VERIFICATION OF CP&L REFERENCE  
BWR THERMAL-HYDRAULIC METHODS USING  
THE FIBWR CODE  
AMENDMENT 1

RESPONSE TO NRC QUESTIONS

MARCH 1984

This amendment to Topical Report NF-1583.04, "Verification of CP&L Reference BWR Thermal-Hydraulic Methods Using the FIBWR Code," is provided in response to requests for additional information as conveyed by the letter to Mr. E. E. Utley, CP&L, from Mr. Domenic B. Vasallo, NRC Division of Licensing, dated January 17, 1984.

FIGURE-12 a

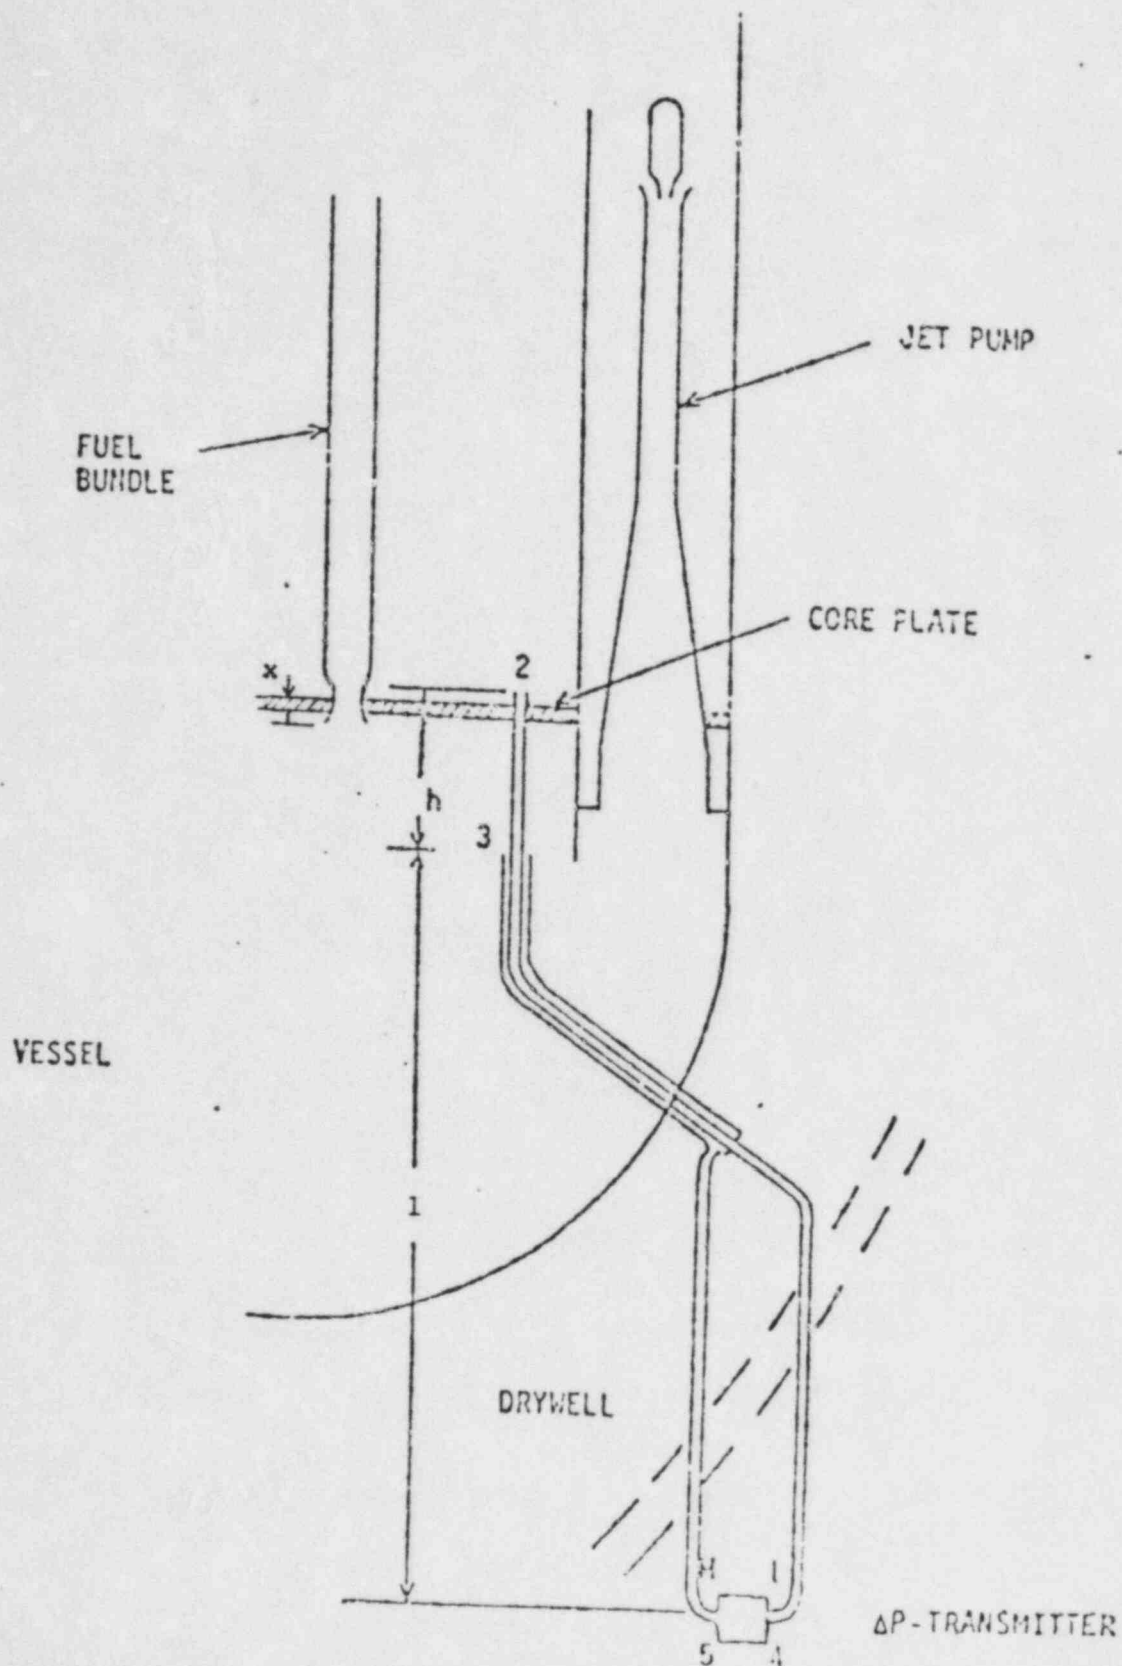
Discuss if there were any corrections to the FIBWR calculated pressure drop across the core support plate to match the exact locations where the pressure tap measurements were made (cf. Table 6). If the locations for calculated and measured  $\Delta P$ 's are different, the errors could be large in low-flow situations where the static head becomes more important than that in high-flow situations.

The measured core support plate pressure drop ( $\Delta P_m$ ) is determined from pressure taps located in the Standby Liquid Control System illustrated in FIGURE 12a.

Using the notation in FIGURE 12a,

where:  $\Delta P_{\text{flow}}$  = flow losses through core support  
 $X$  = elevation between the center line of the inlet orifice and the top of the core support plate. (See FIGURE 12a)

We consider 0.11 psi to be negligible and, therefore, no correction term was applied to the figures in Table 6 of the topical report.

Fig 14-b

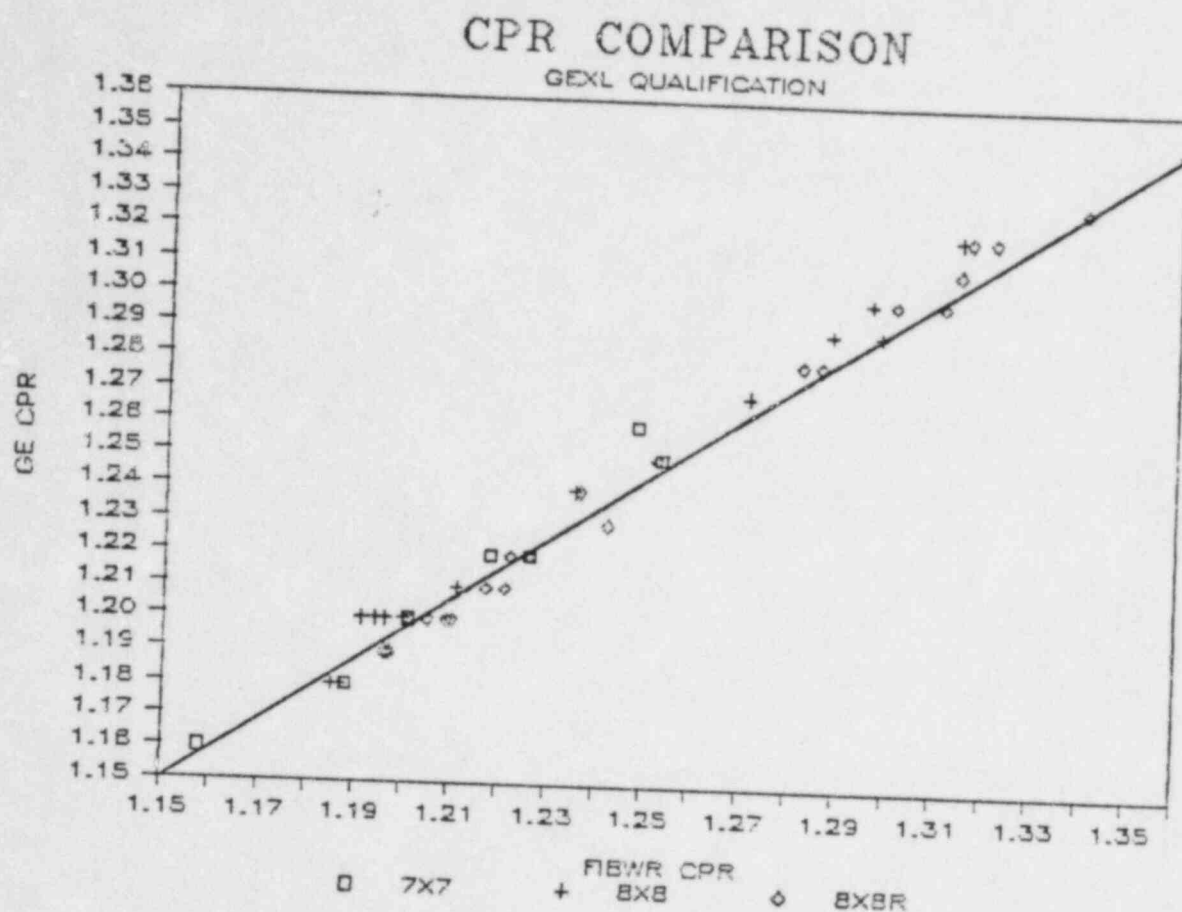
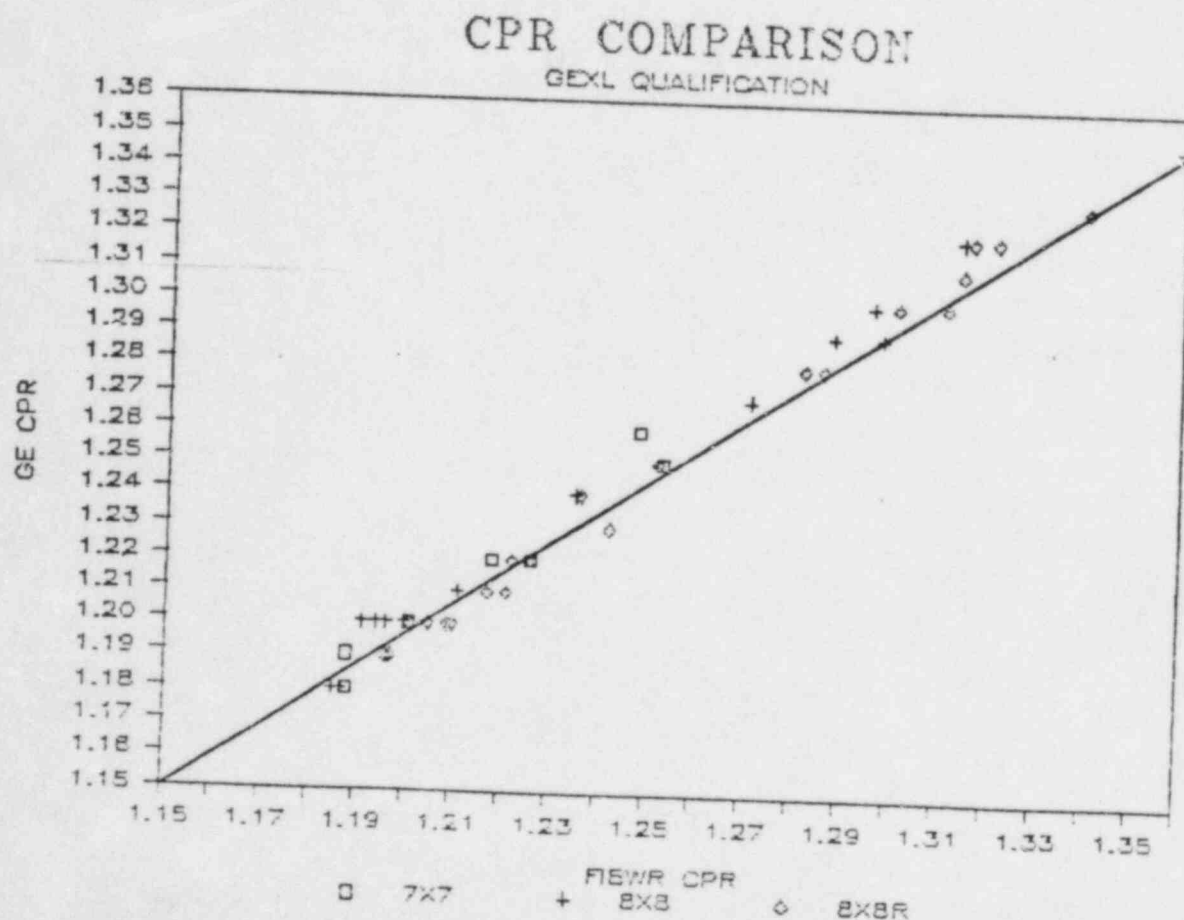
Provide the documents that give the vendor-calculated critical power ratios used in Figures 6 and 7 data comparisons.

The cover page from each of the above documents, accompanied by the pages containing the local channel conditions, are provided as attachments. Documents 4 through 7 are draft versions of reload submittals which had not been published at the time that the local conditions were used for benchmarking purposes. Attachment 8 is a formal transmittal of data which was previously supplied to Carolina Power & Light Company by General Electric Company for information purposes only. The data point for the 100%, 7x7 channel case given in the formal transmittal differed from the initial data which was used in the FIBWR benchmark. This new data point has been evaluated using the GEXL

correlation in FIBWR, and the resulting change to Figure 7 of the topical is illustrated in Figures 14--a and 14-b. Figure 14-a is a reproduction of the original Figure 7, and Figure 14-b shows the same figure with the new 7x7 data point.
